MEMORANDUM

Re: Charles Washington Hall
ADDENDUM No. 6

Project: Charles Washington Hall

SK
2

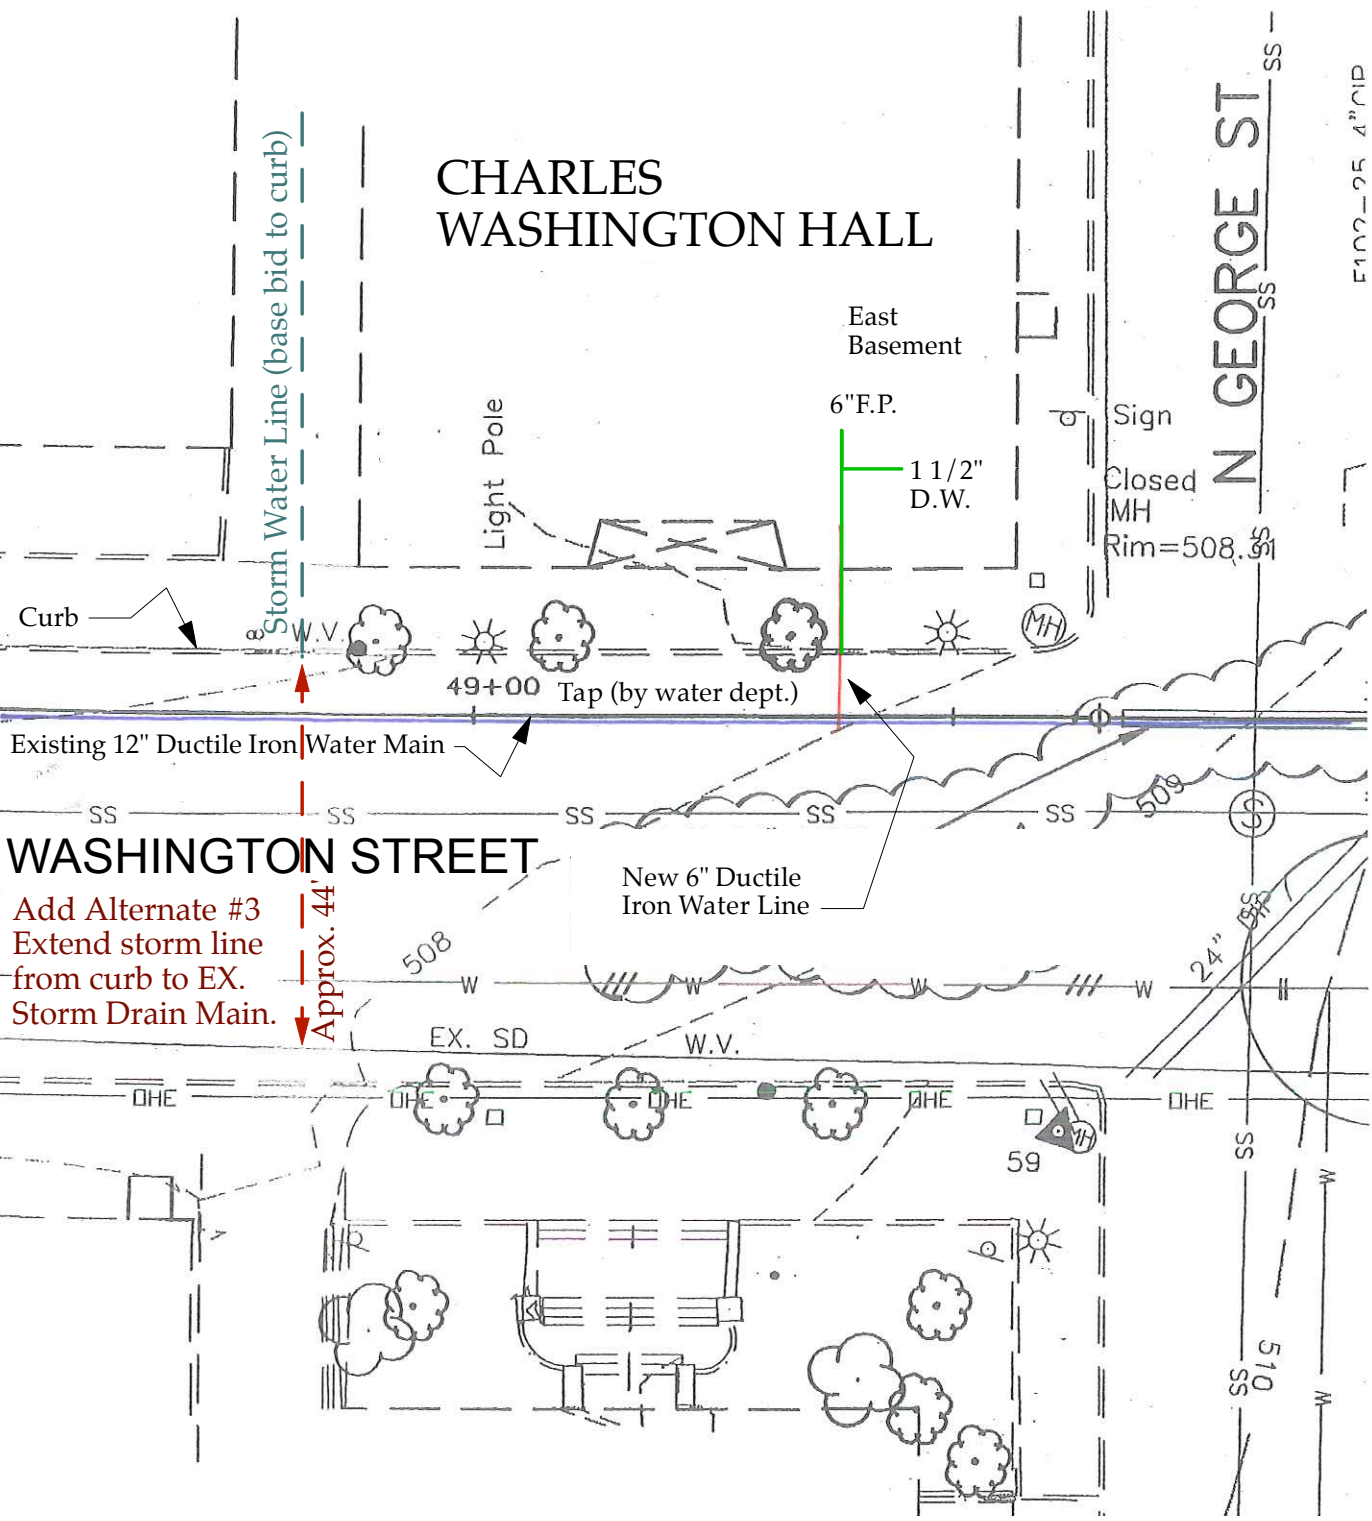
3. The Form of Proposal has been updated to include acknowledgements for all six addenda and Add Alternate #3 extending the storm sewer from the curb line to the storm sewer main. Please see attached Form of Proposal Rev. and SK3.

20. On drawing P3.1, the new 6" water line will enter the building on the south façade (Washington Street) instead of the east (George Street). The new water line will be tapped into the existing 12" ductile iron water main on Washington Street which runs about 5' south of the curb line. See attached SK-2. The 6" water line work between the main and the curb will be completed by the Water Department. The Contractor will connect to a ductile iron pipe flange at the curb and extend into the East Basement where the domestic water will branch off to various components such as the meter and other fittings as called out on the drawings. The Contractor shall be responsible for backfilling trench as per the Water Department's regulations as stated in the water and sewer manuals found on CTUBWV.com . The water line is approximately 4 feet below grade. Minimum depth requirement of the water line is 42". The City will be responsible for all tap and review fees.

21. The new waste water line shall reconnect to the existing PVC sewer line exiting the building from the West Basement.
22. The Contractor shall be responsible for the installation of the new storm water line shown on drawing L1.2. Provide a separate cost (add alternate #3) to extend the storm water line from the curb line to the main line across the street. (see SK-2). Review fees, if any, for this work will be paid by the City. The WVDOH provides minimum specifications for backfilling and pavement patching of State highways.

Add Alternate #3
 Extend storm line
 from curb to EX.
 Storm Drain Main.
